Access Compliance Report

Public Rights-of-Way

(Curb Ramps)

Intersection ID: 29128	Main Street: HIGHLAND_PARK_DR	Cross Street: HUNTERS_CREEK_CT	Location: E
ADA ID: 0DDF7AAB5C09	Ramp Type: PerpDiag	Initial Pass/Fail: Pass	Overall Compliance: No
Severity Score: 7.5			
Codes/Mitigation Info/Possible Solution		Field Measurements/Component Compliance

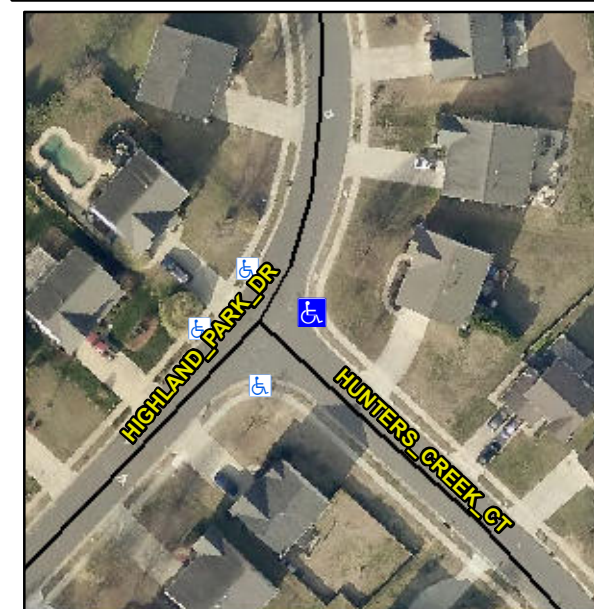
Remove & Replace Curb Ramp With Two New Directional Ramps or Equivalent. Remove & Replace Gutter.

R304.2.2-Perp, R304.3.2-Para, R305.1.4, R302.7.2, R304.5.3
